**Site-Specific Sampling and Analysis Plan  
Remedial Investigation at TNT Area B  
Former Plum Brook Ordnance Works  
Sandusky, Ohio**

**RESPONSE TO OEPA TECHNICAL REVIEW COMMENTS  
DRAFT WORK PLANS FOR THE TNT AREA B RI/FS  
PLUM BROOK ORDNANCE WORKS, SANDUSKY, OHIO**

**RESPONSES TO TECHNICAL REVIEW COMMENTS**  
**DRAFT SITE-SPECIFIC SAMPLING AND ANALYSIS PLAN (SSAP) AND**  
**SITE-SPECIFIC SAFETY AND HEALTH PLAN (SSHP), RI/FS OF TNT AREA B**  
**PLUM BROOK ORDNANCE WORKS, SANDUSKY, OHIO**

**FIGURE IX-2  
LOCATION MAP**

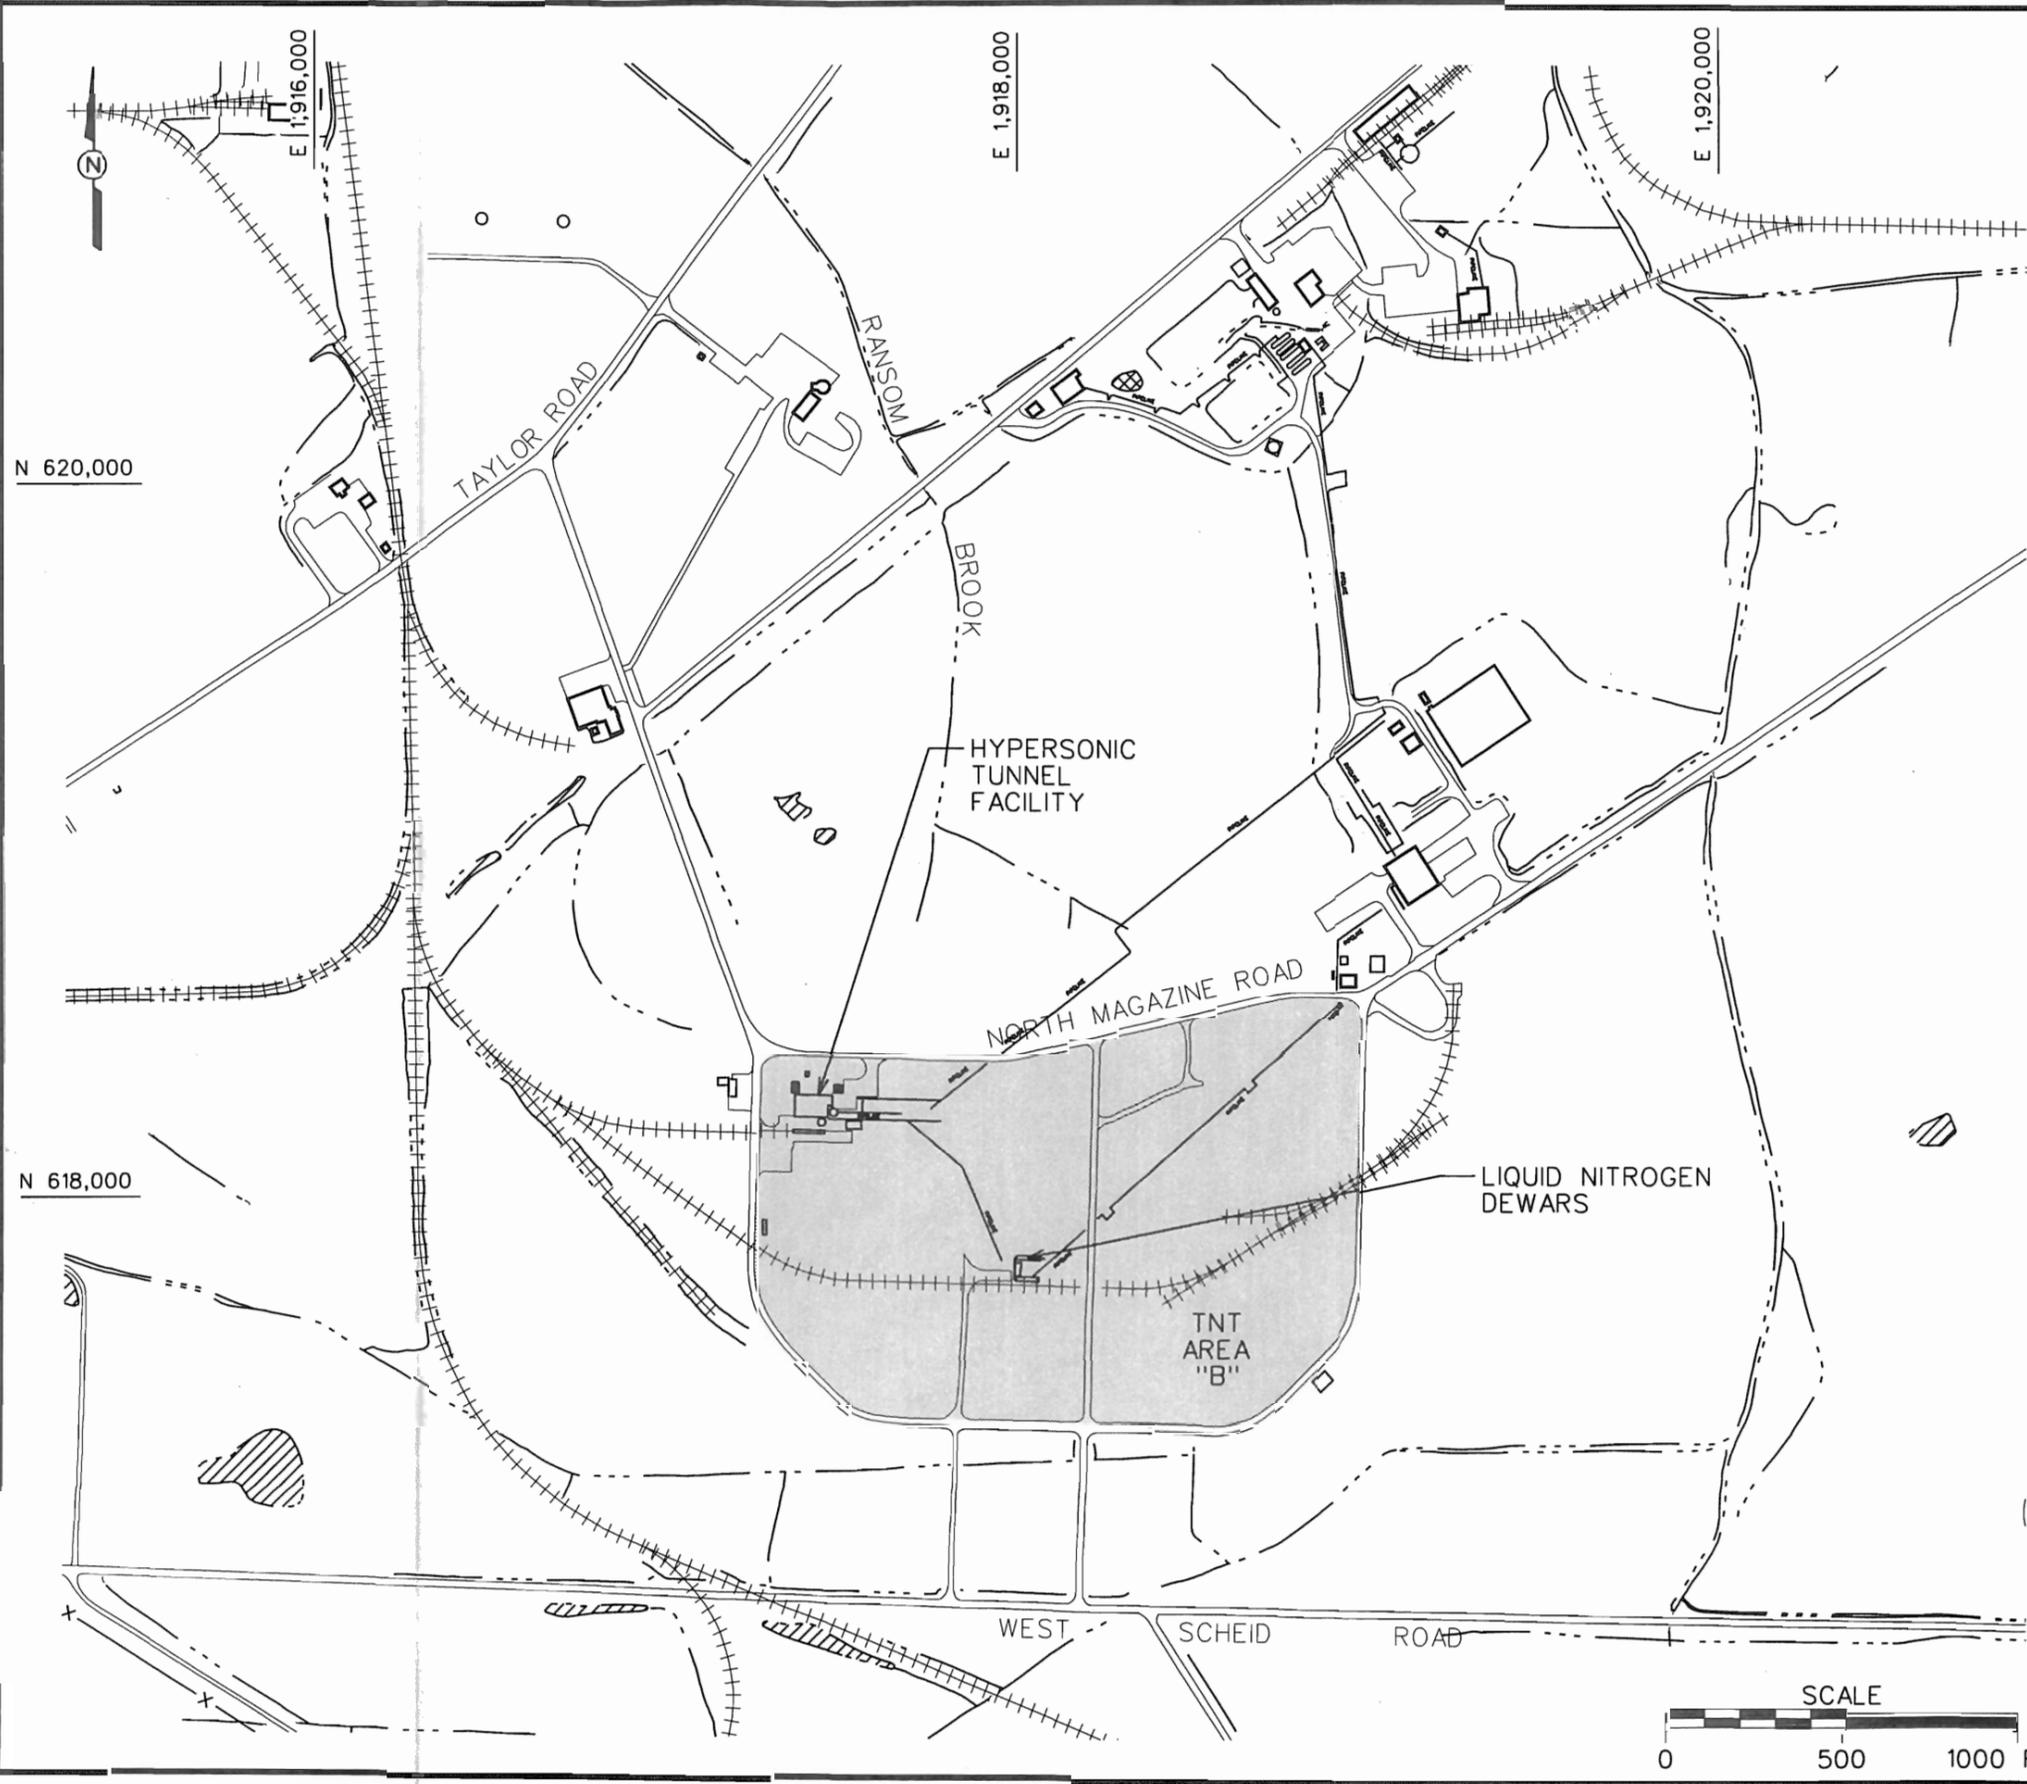
**Comment 30.** Figure IX-2: Identify the structures show within the shaded region.

**Response:** *Agreed. The Hypersonic Testing Facility and the Liquid Nitrogen Dewars structures have been identified on the figure.*

**FIGURE IX-3  
PROPOSED SURFACE SOIL BORING LOCATIONS**

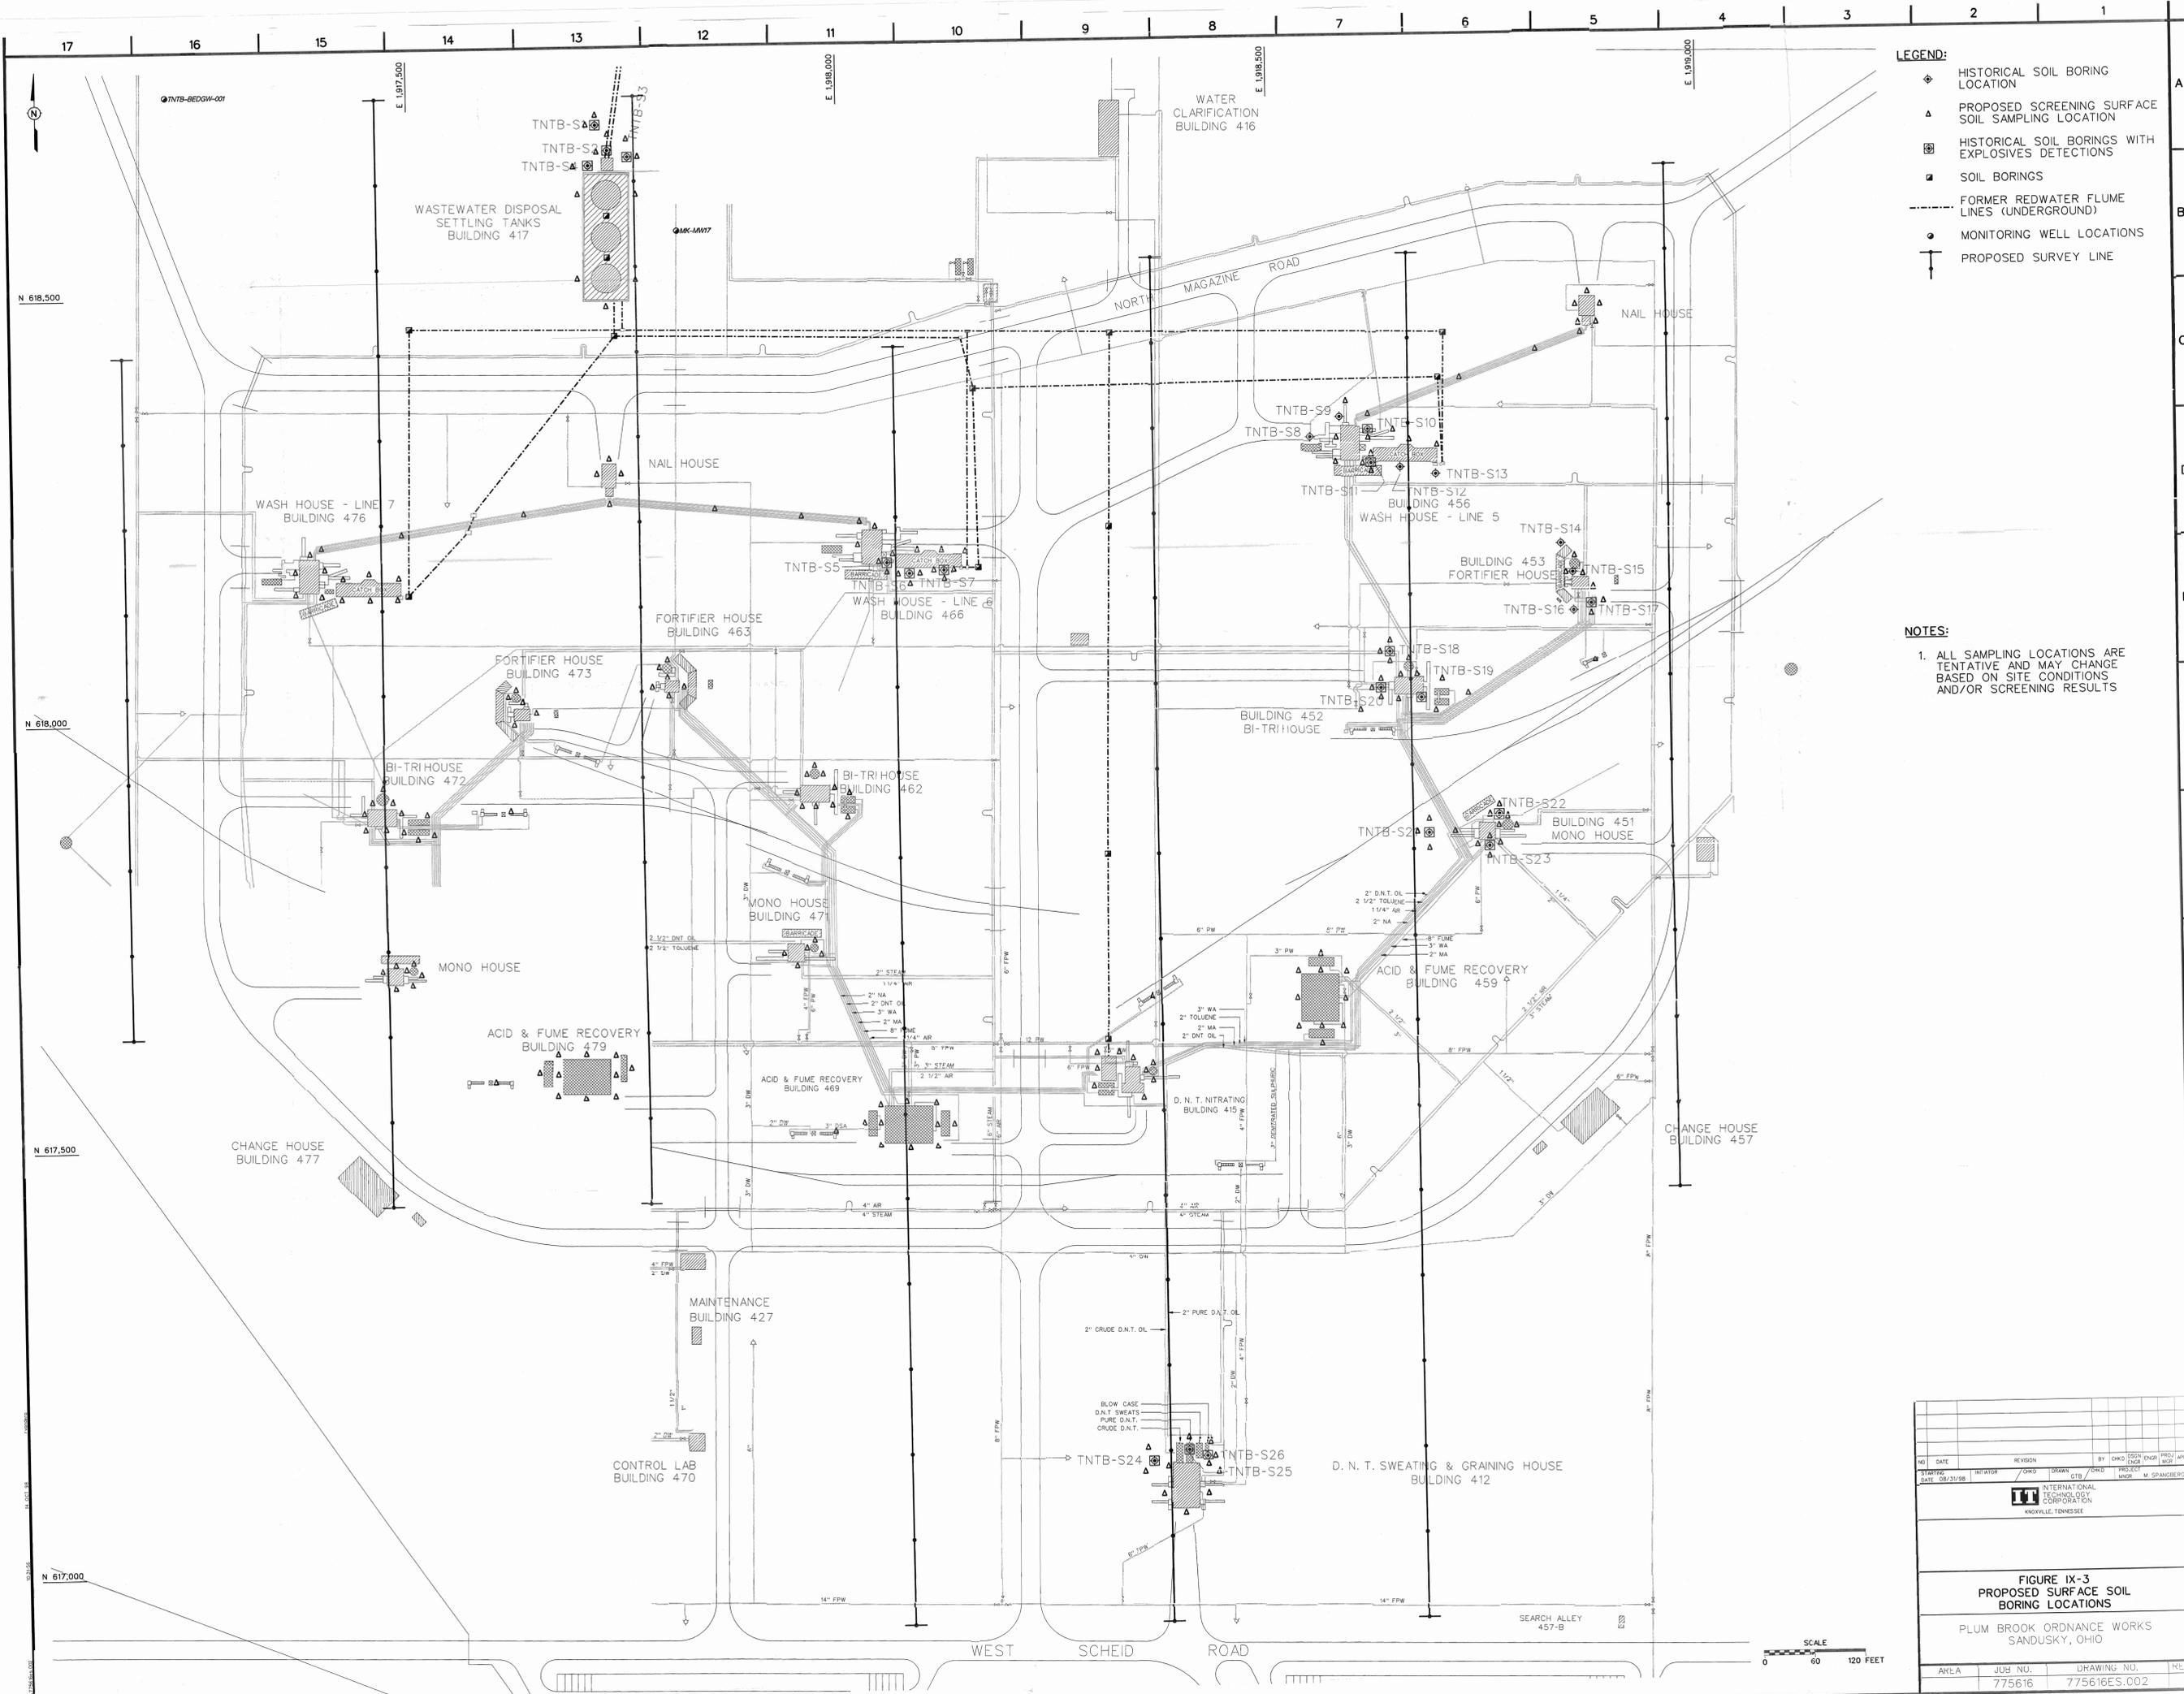
**Comment 1.** [SSAP, Figure IX.3] The figure is missing from the SAP. Could not review sample locations.

**Comment 12.** [SSAP, Section IX.4.1, Last Paragraph] Please describe how the grid sampling will be integrated with the building oriented sampling described in the previous paragraph and shown in Figure IX-3.

**Comment 37.** Full Sized Figure IX-3: What do the solid, black lines represent. They are not identified on the legend.

*Response: It is unclear why Figure IX.3 was not included in Mr. Peacock's copy of the SSAP. However, the figure will be included in the final submittal.*

**Response:** *The "grid sampling" is part of the building-oriented sampling. Because the historic building locations are known but are not always readily discernable by remnants of foundations, the grid will be used to reference sample locations to known coordinates at the site. This will permit accurate location of these points in the future if required (i.e., during remedial actions, etc.).*

*Response: The solid black lines represent the location of the survey grid that will be used to determine the sample locations. The Figure IX-3 will be modified to include this information.*

**FIGURE IX-1**  
**SITE AND HOSPITAL**  
**LOCATION MAP**

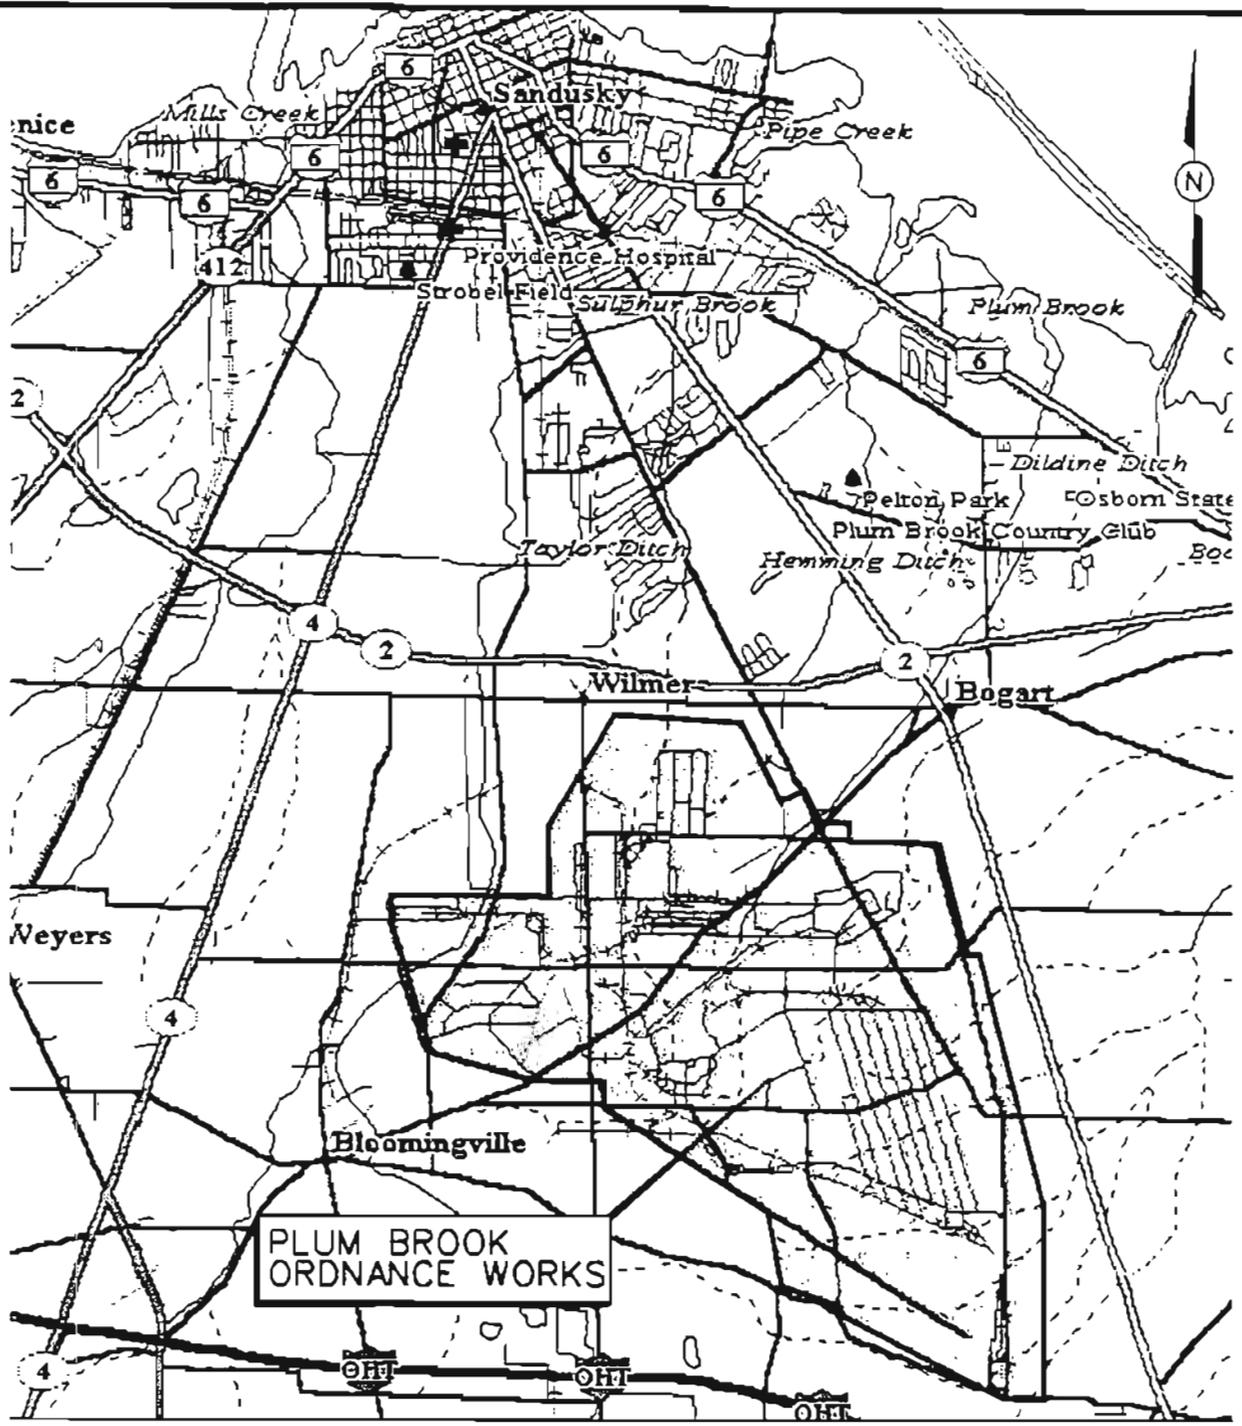
**Comment 2.** [Part IX.2.0, Site Characterization and Analysis, Section IX.2.2 General Site Information, Figure IX-1] Please identify U.S. Route 250 on the site and hospital location map.

*Response: The requested information is provided on Figure LX-2.*
